PROPOSED CHANGE NOTICE

2445-30

RE: AURORA FOOD STORE
2000 ANAQUOD ROAD
REGINA, SK
Commission No. 2445

RE: Vestibule TV Power/Data

TITLE:
DOR PLAN -
WER

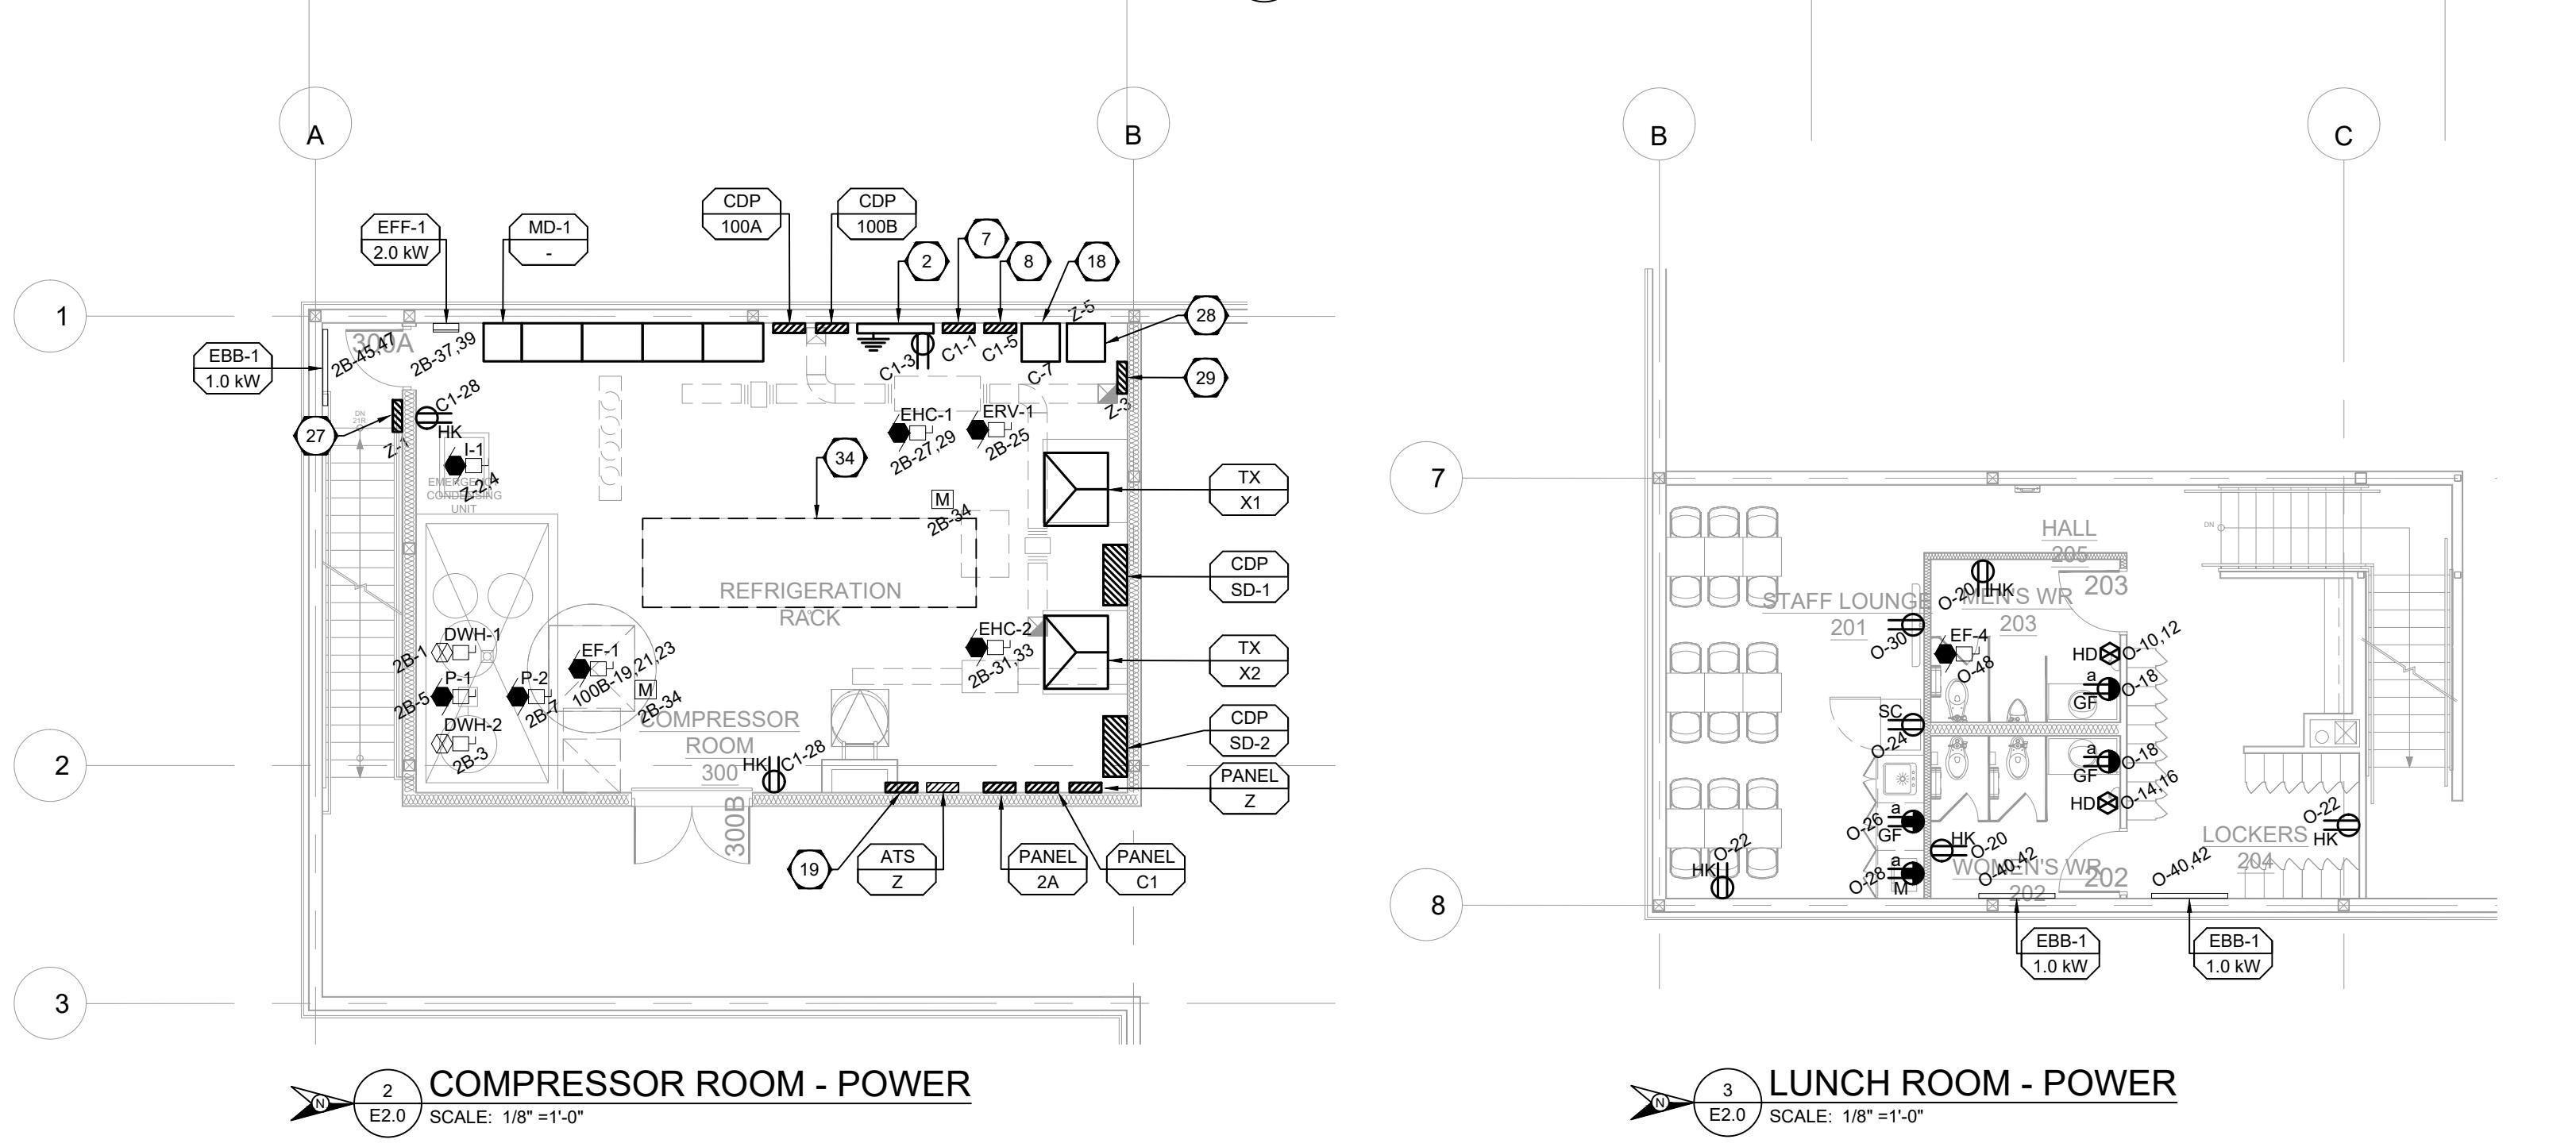
1. Refer to attached drawing E0.3 for one(1) additional 15A-1P breaker added to panel 'C2' for the vestibule TV screen.
2. Refer to attached drawing E2.0 for the location of one(1) additional receptacle in 'Vestibule 100' for the vestibule TV screen. Coordinate the height of the TV receptacle with décor drawings and TV mounting brackets.
3. Refer to attached drawing E5.0 for the location of one(1) additional data outlet in 'Vestibule 100' for the vestibule TV screen. Mount data at same height as receptacle and provide 2" separation from the receptacle.
